**Report: TAB REPORT**  
**Function: Test, Adjust, & Balance**  
**Date: 10/06/2023**

## 09-04-23 PENN STATION - BELLEVUE, NE

Project: 09-04-23 PENN STATION - BELLEVUE, NE

**GRD**  
**09/11/2023**

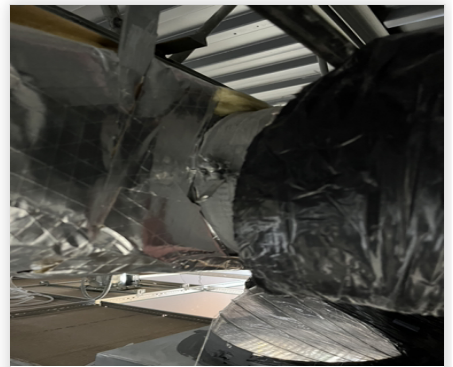
**Issue Name :** DIFFUSER 2-9 plastered shut  
**Description :** Damper on diffuser 2-9 on the GRD is plastered shut and is allowing no airflow through. The damper needs to be free to be locked down at the proper airflow.  
**Created By :** National TAB                      **Assigned To :** National TAB - Jacob Davidson  
**Status :** Open  
**Originated Date :** 09/11/2023 - Jacob Davidson - National TAB

**EF3(1)**  
**09/12/2023**

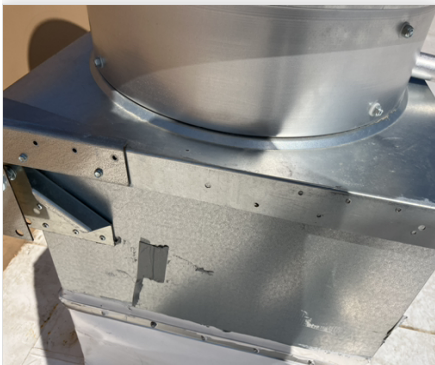
**Issue Name :** EF1 and EF3 air leakage  
**Description :** On the sides of EF1 and EF3 there is air leakage which will have grease escape onto the roof. Recommend sealing off the sides of these fans.  
**Created By :** National TAB                      **Assigned To :** National TAB - Jacob Davidson  
**Status :** Open  
**Originated Date :** 09/12/2023 - Jacob Davidson - National TAB
